CRC project

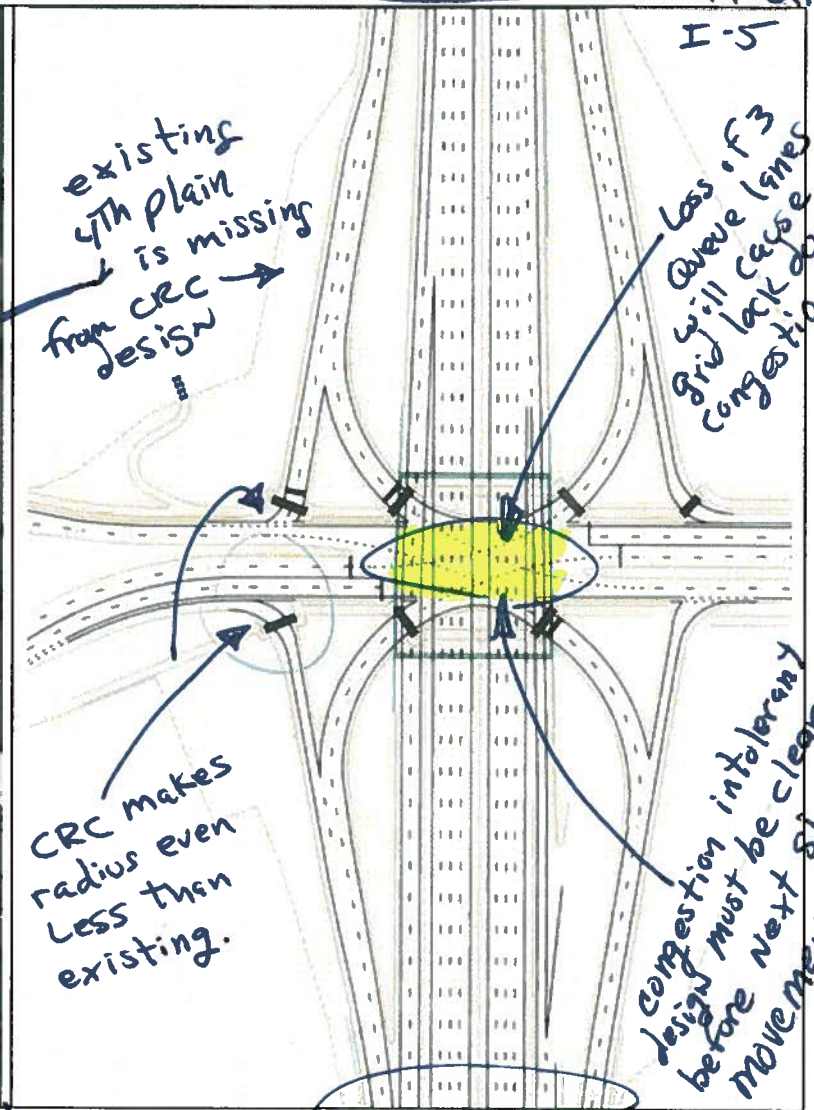
NOT conflict with existing

existing 4th plain is missing from CRC design

Less of F3 gridlock cause congestion

CRC makes radius even less than existing.

congestion intolerant design must be clear before next movement signal

8 lanes just fit under evergreen overpass
